Serial No.: 21-138A  
NRA/GDM: R2  
Docket Nos.: 50-280  
50-281  
License Nos.: DPR-32  
DPR-37

**VIRGINIA ELECTRIC AND POWER COMPANY**  
**SURRY POWER STATION UNITS 1 AND 2**  
**PROPOSED LICENSE AMENDMENT REQUEST**  
**REMOVAL OF REFUELING WATER CHEMICAL ADDITION TANK AND**  
**REPLACEMENT OF CONTAINMENT SUMP BUFFER**  
**SUPPLEMENTAL INFORMATION**

**RESPONSE TO NRC REQUEST FOR SUPPLEMENTAL INFORMATION**

**REMOVAL OF REFUELING WATER CHEMICAL ADDITION TANK AND  
REPLACEMENT OF CONTAINMENT SUMP BUFFER**

Figure 6.3-1  
CONTAINMENT SPRAY SUBSYSTEM

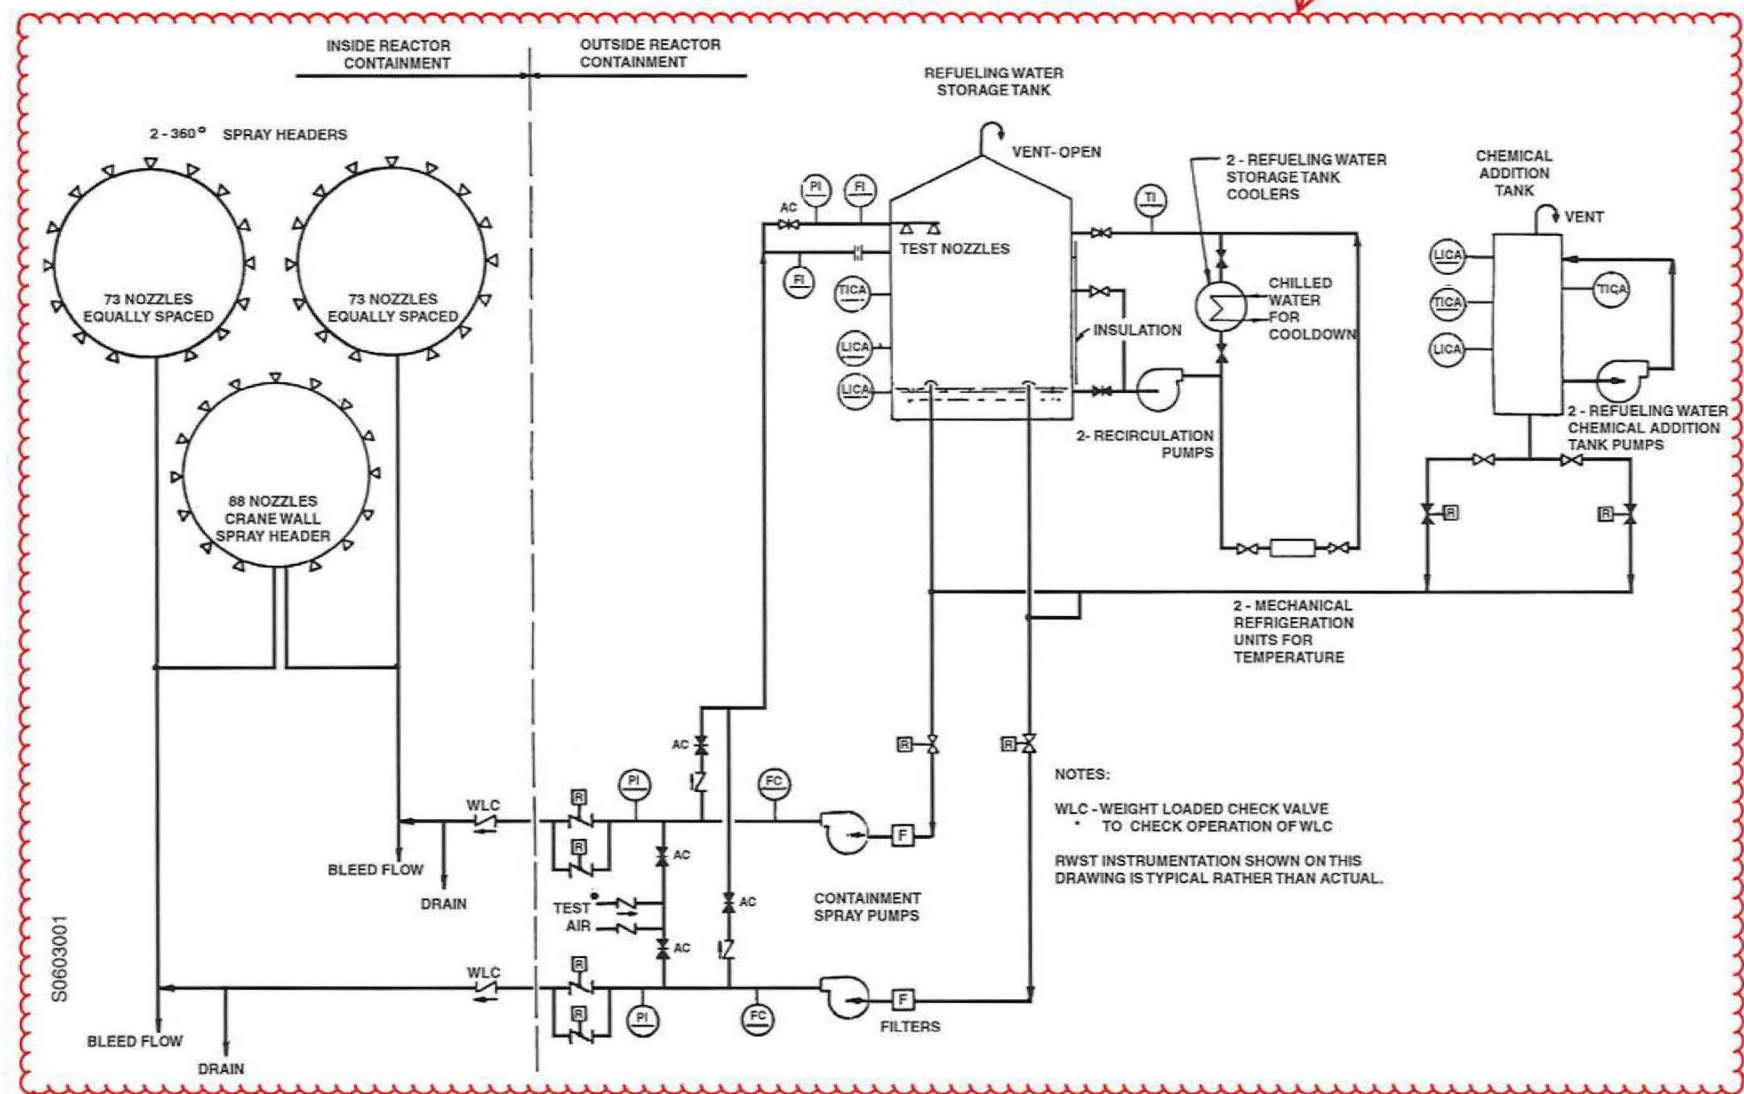
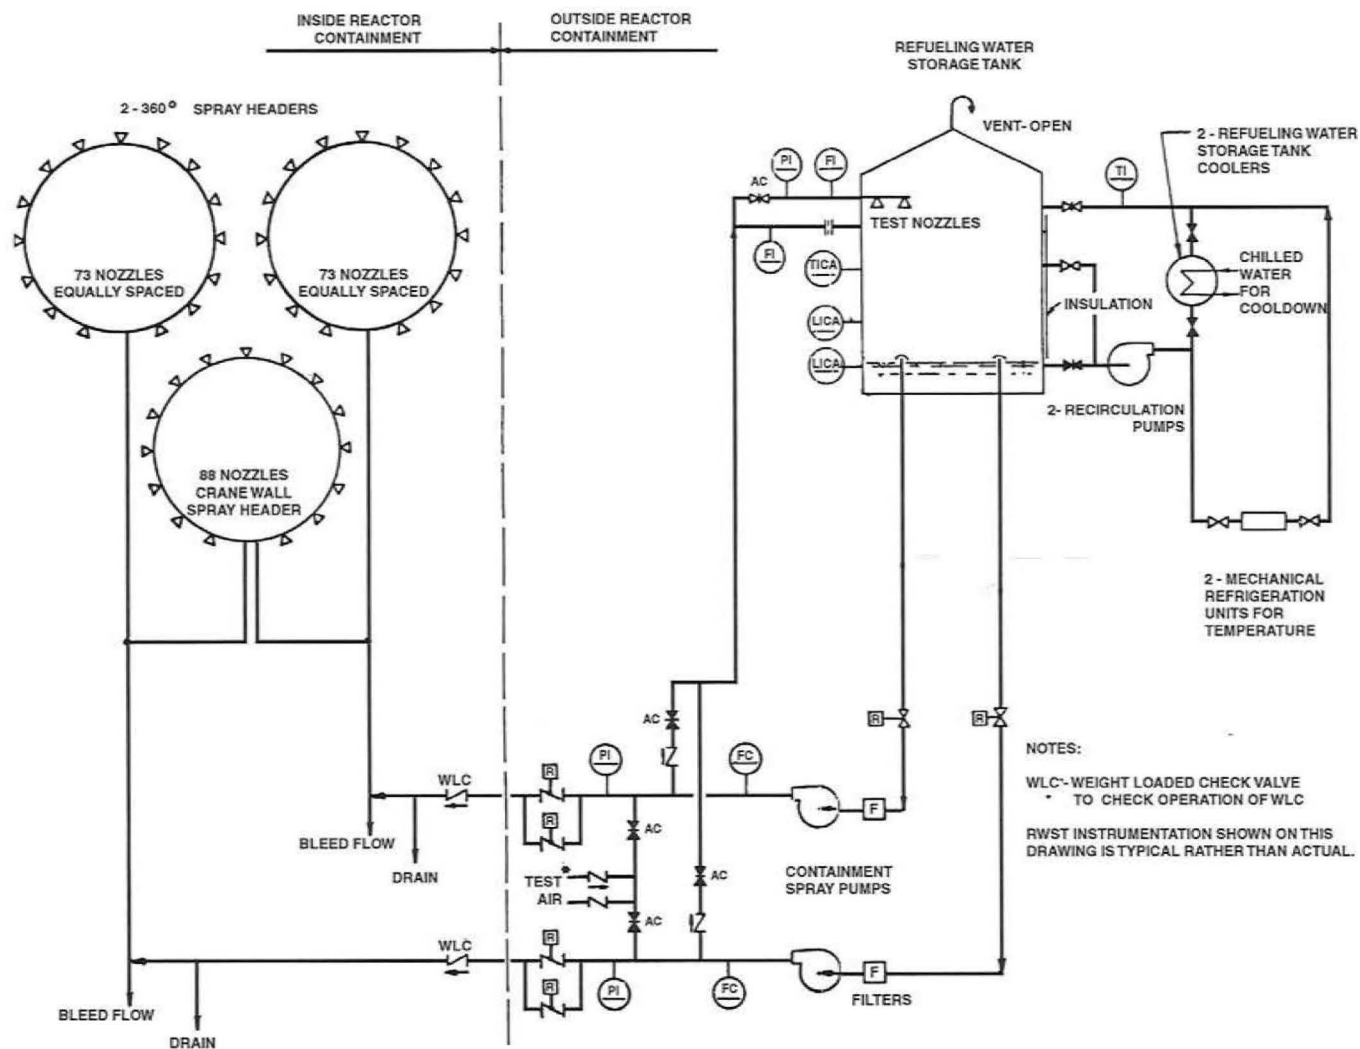
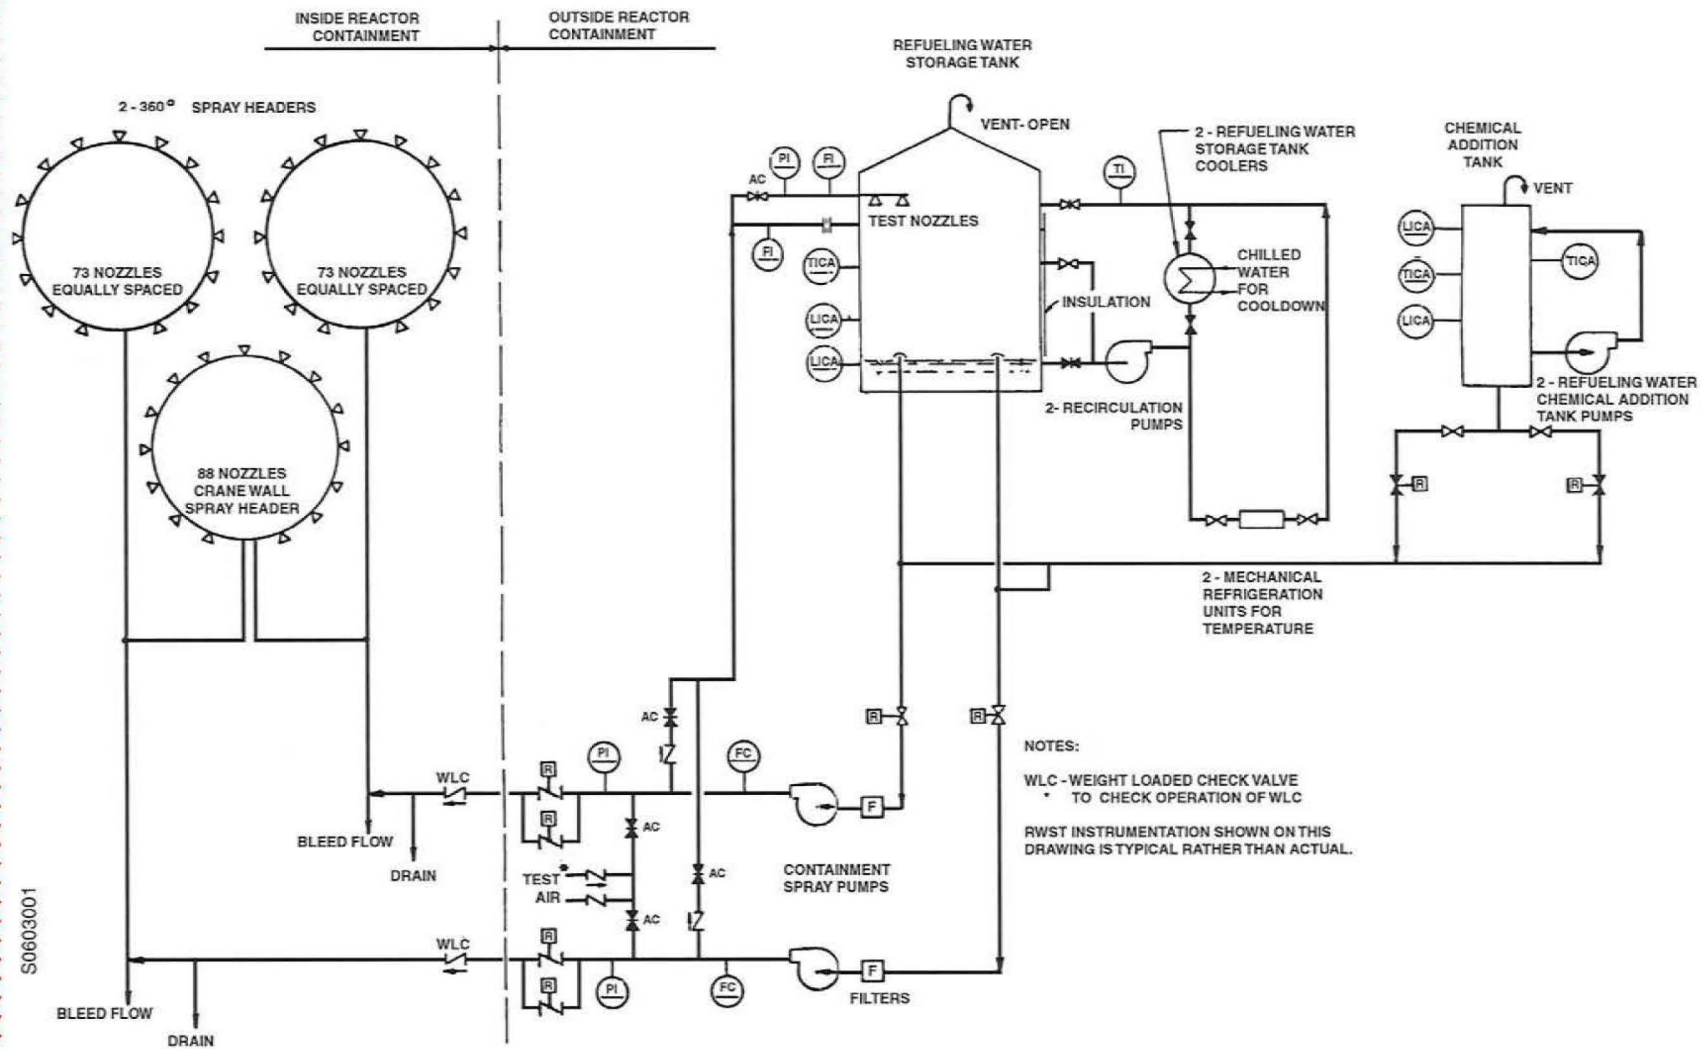
REPLACE WITH INSERT E

ADD NEW FIGURE 6.3-1b  
ON NEW PAGE 6.3-26b  
AFTER FIGURE 6.3-1a

Figure 6.1-2  
UNIT 2 ENGINEERED SAFEGUARDS SYSTEMS

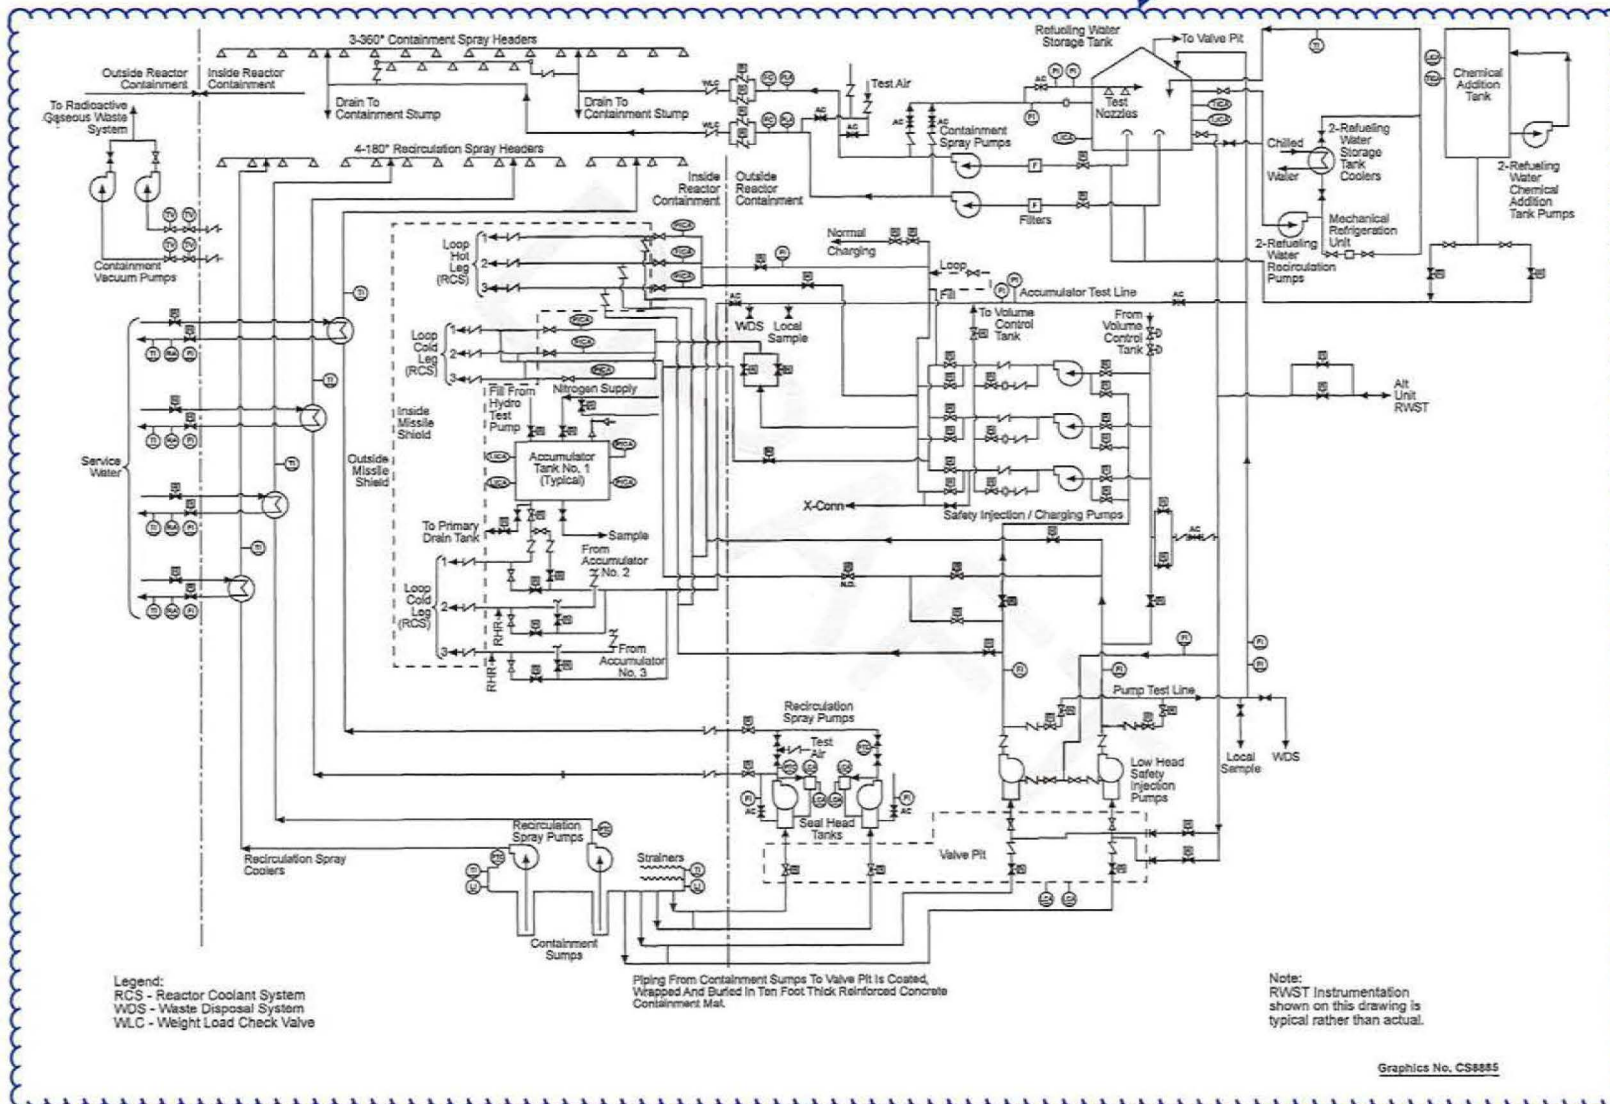
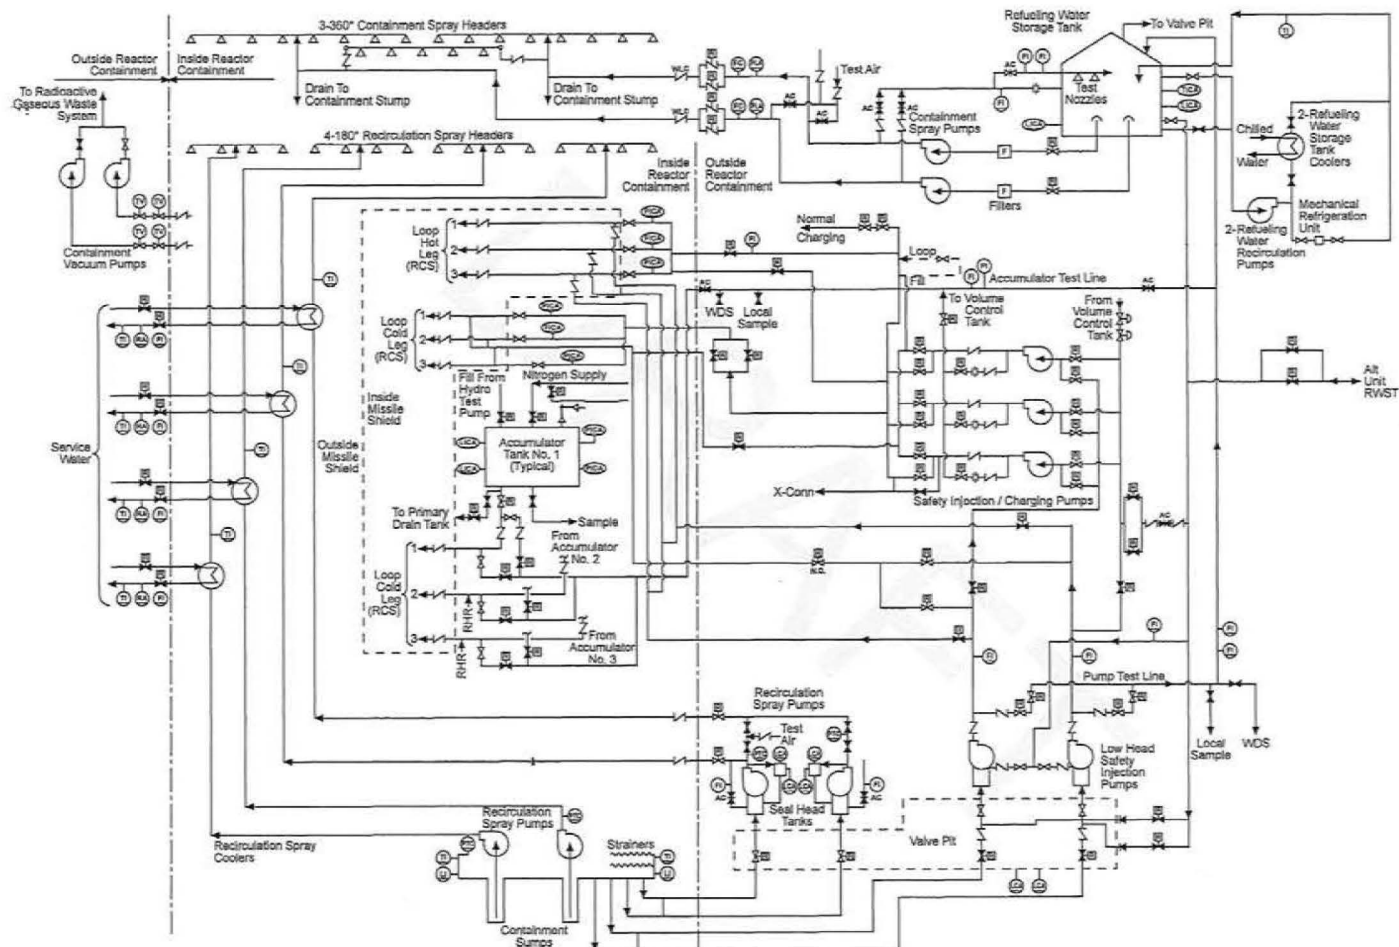
REPLACE WITH INSERT A

Sodium Tetraborate Decahydrate (NaTB) is stored in baskets inside containment to increase the alkalinity of the sump water produced during an event which exceeds the CLS high-high containment pressure actuation setpoint, which is recirculated by the recirculation spray subsystem to ensure effective removal of radioactive iodine (Unit 1).

Figure 6.3-1b  
UNIT 2 CONTAINMENT SPRAY SUBSYSTEM

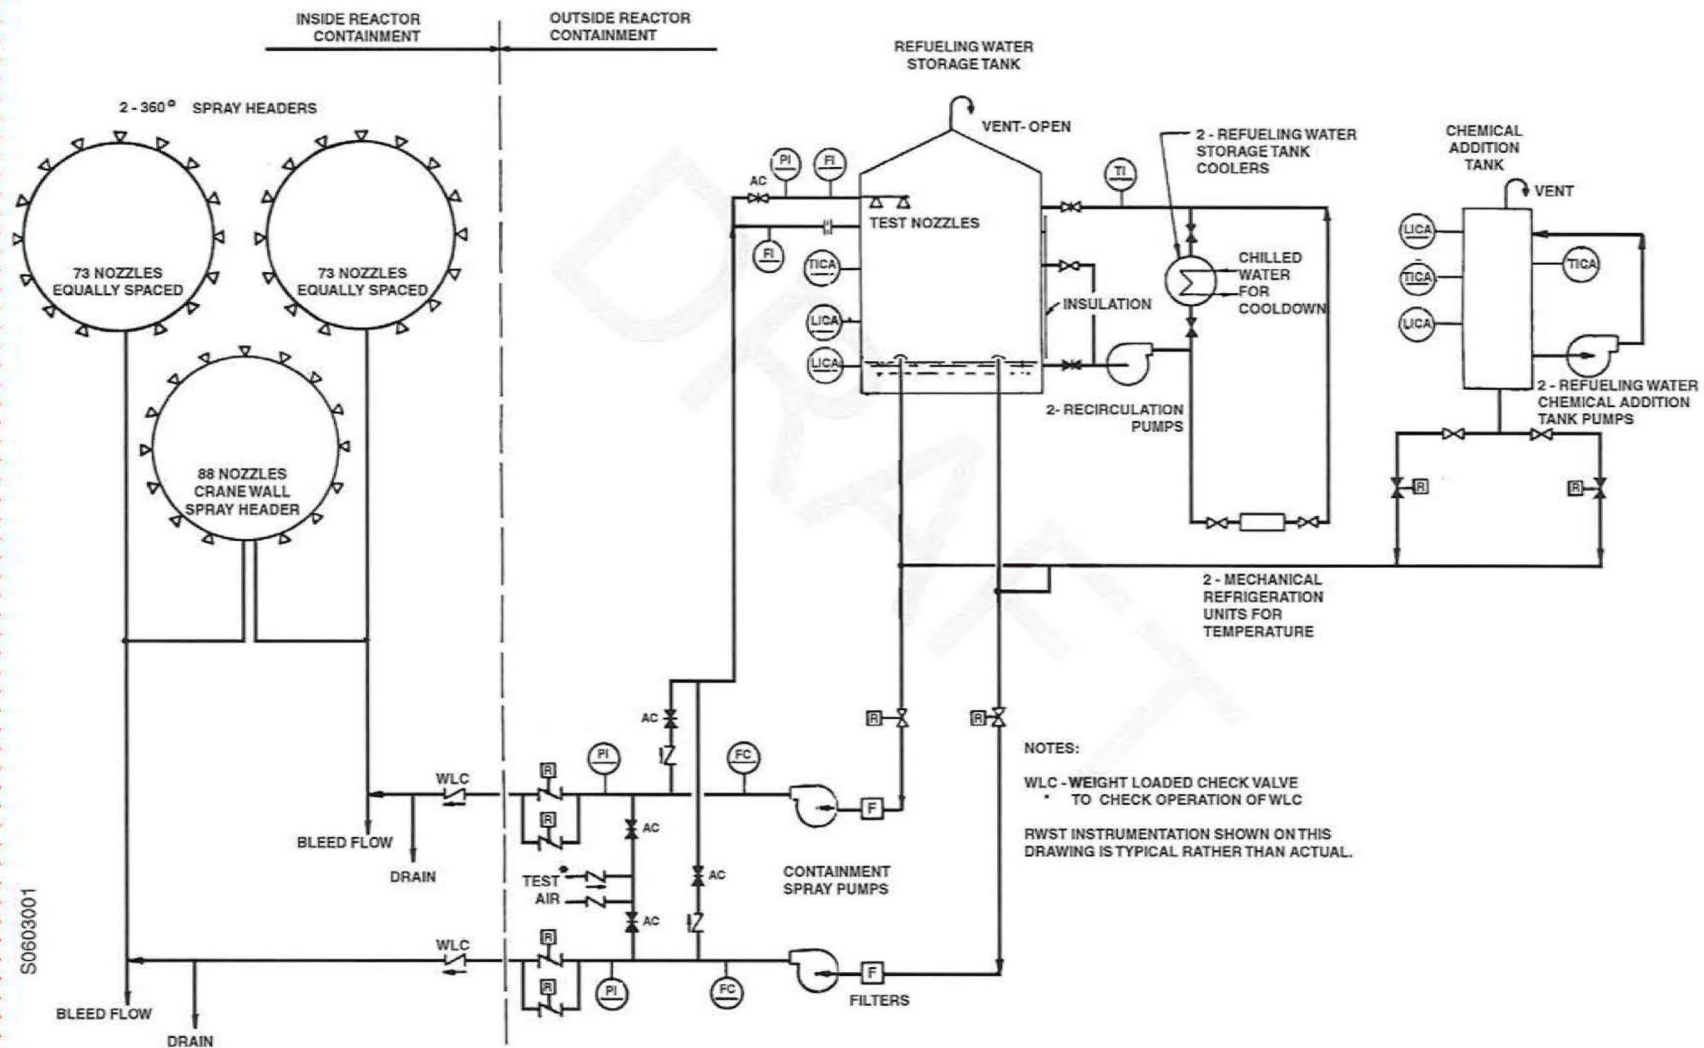
REMOVE FIGURE AND PAGE

ADD NEW FIGURE 6.3-1b  
ON NEW PAGE AFTER  
FIGURE 6.3-1a
